CITY PLANNING COMMISSION

APPLICATION: 1. Variance to waive requirement of six-foot masonry wall adjacent to residential use/zone
2. Lot Line Merger

LOCATION: 5609, 5629 'J' Street

PROPOSAL: The applicant is requesting the necessary entitlements to merge three adjacent lots totaling 0.5± acres in the General Commercial (C-2) zone to develop a doctor's offices and parking.

ZONING MAP

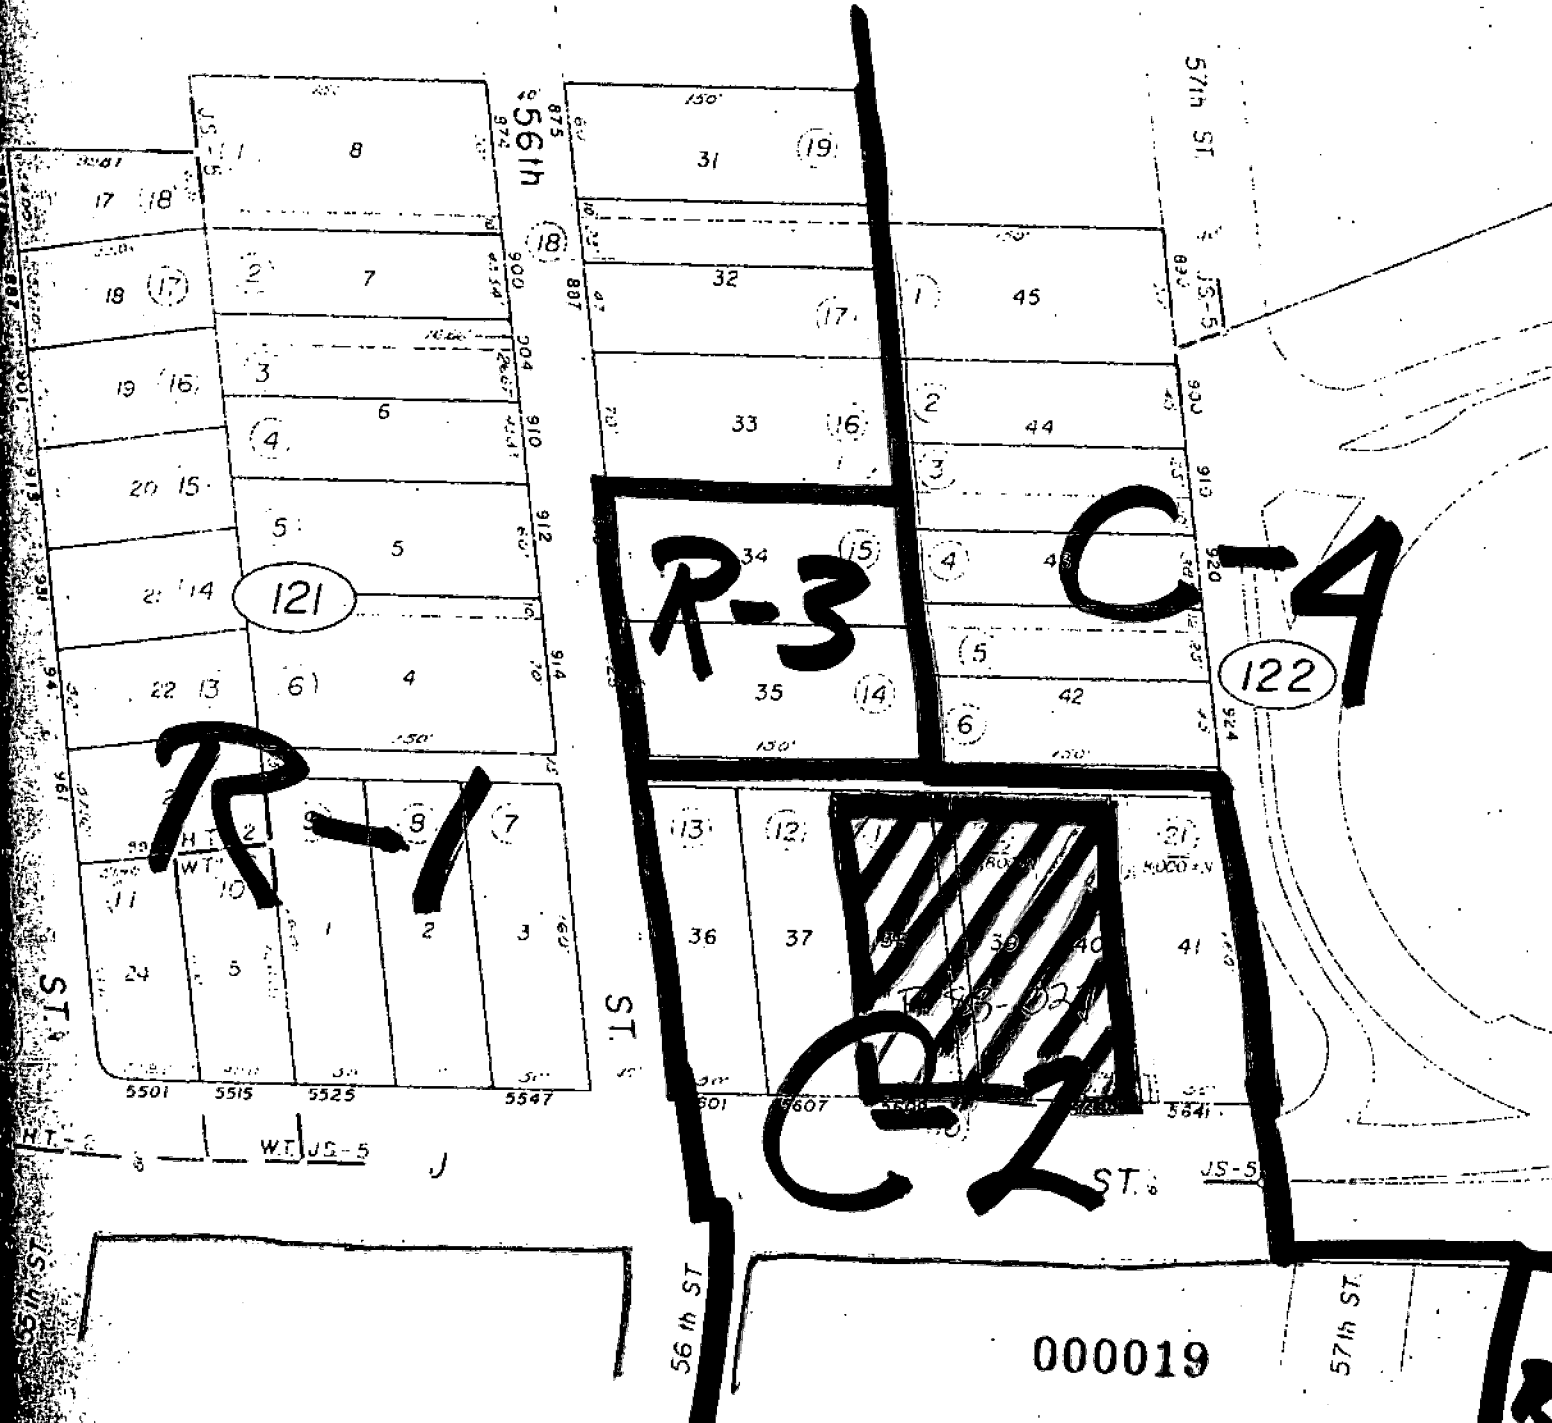
2. Residential zone (R-3) use abuts approximately one-third of the rear property line across the alley. Requiring a six-foot masonry wall for only this portion, when the majority is abutted by C-4 and the remains of the property surrounded by C-2, is unnecessary under these circumstances. Staff suggests that a landscape planter area be provided in lieu of the wall.

- a. Applicant shall provide a minimum four-foot wide planter, plus six-inch high/wide vertical curbing surrounding planter along the entire rear portion of the proposed project abutting the alley. The planter shall have a mixture of screening shrubs that can be maintained at three feet and minimum 15-gallon size trees appropriate to parking lot landscape. If the alley is fully improved, the planter may be broken for approved ingress/egress and/or backout parking;
- b. A landscape/irrigation plan shall be reviewed and approved by the Planning staff prior to building permit issuance;
- c. Any lighting shall be directed away from and shielded from adjacent residential uses.
